RUST ON BOTTOM OF REAR DOOR GLASS GUIDE

Bulletin No: 09-014/14**Last Issued:** 02/25/2014**BULLETIN NOTE**

2010-2013 Mazda3 (including Mazdaspeed3)

Vehicles Type A

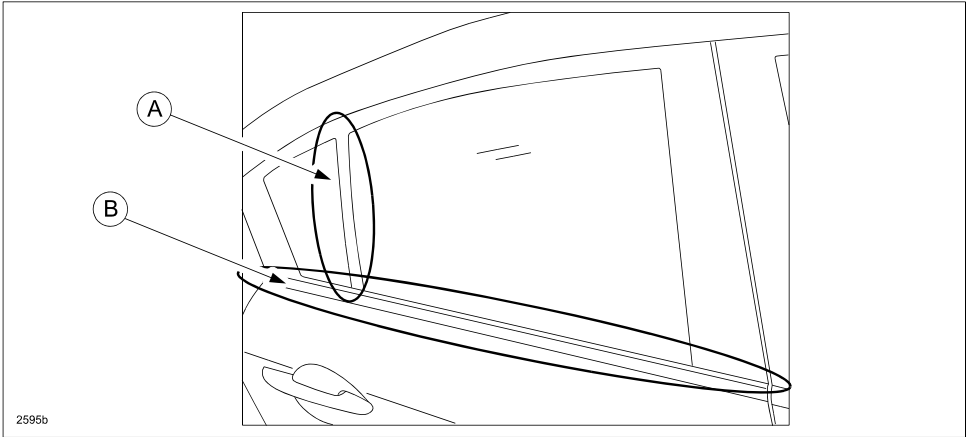
Some vehicles may exhibit rust on the bottom of the rear door glass guide (A) from contact with the rear beltline molding (B). This is caused by a vibration while driving.

At the affected side(s), replace both the the rear door glass guide assembly and the rear beltline molding with modified ones. Refer to MS3 online instructions or Workshop Manual section 09-12 REAR DOOR QUARTER GLASS REMOVAL/INSTALLATION and 09-16 REAR BELTLINE MOLDING REMOVAL/INSTALLATION.
